Application for Licence Amendment

Licence Number	L9223/2019/1
Licence Holder	Yara Pilbara Nitrates Pty Ltd
ACN	127 391 422
File Number	DER2019/000564
Premises	Yara Pilbara Nitrates TAN Plant Village Road BURRUP WA 6714 Legal description – Part of Lot 3017 on Deposited Plan 50979 As defined by the coordinates in Schedule 2 of the Licence
Date of Report	3 February 2026
Decision	Revised licence granted

Schedule 1: Decision Report for Works Approval W6639

Works Approval Number	W6639/2022/1
Applicant	Yara Pilbara Nitrates Pty Ltd
ACN	127 391 422
File number	DER2021/000662
Premises	Yara Pilbara Nitrates TAN Plant Village Road BURRUP WA 6714 Legal description Part of Lot 3017 on Deposited Plan 50979 Certificate of Title Volume 2784 Folio 568 As defined by the premises map and coordinates in the issued works approval
Date of report	10 August 2022
Decision	Works approval granted

Figure 2: Evaporation pond freeboard and spillway

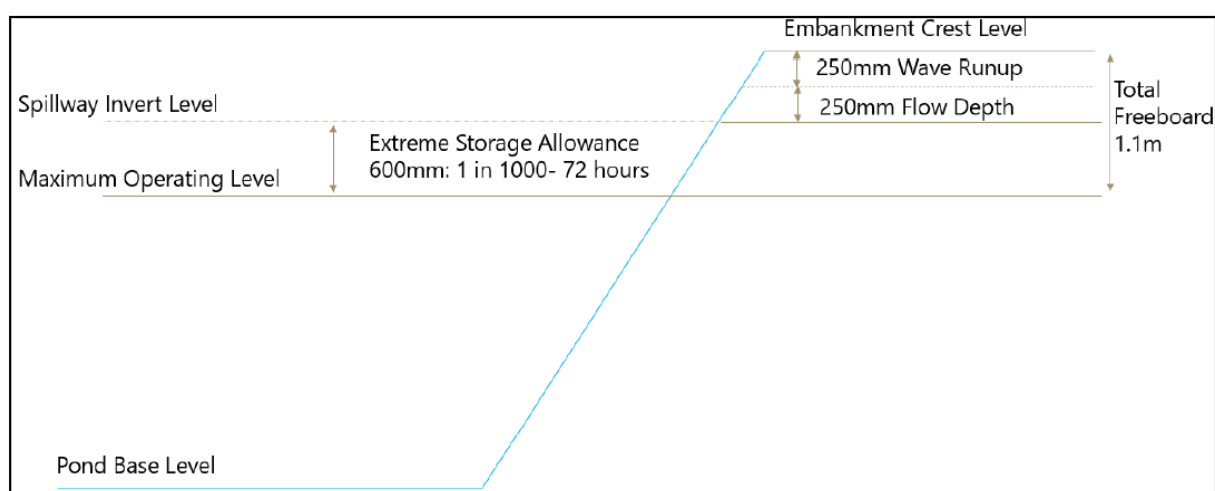
<p>Regarding the embankment erosion that occurred following 62mm of rainfall on 4-5 of March 2024, queried the licence holders claim that the compacted ground underlying the pond membrane (liner system) was not damaged as no evidence was provided. Reiterated that minimal operational period is insufficient for the department to consider changing the frequency of inspections as proposed.</p>	<p>The application stated that embankment surface erosion was observed during the visual inspection and assessed to be occurring in the uncompacted layer on the surface following the 62mm rainfall on 4 and 5 March 2024. The works approval requires reporting of water detection in the recovery sumps and this requirement has been transferred into the licence. No reports of seepage in the sumps linked to this event have been received. As per the risk assessment in section 3, the department determined that reducing inspections from daily to twice weekly will not increase the risk of loss of containment causing impact to surrounding water and ecosystems.</p>
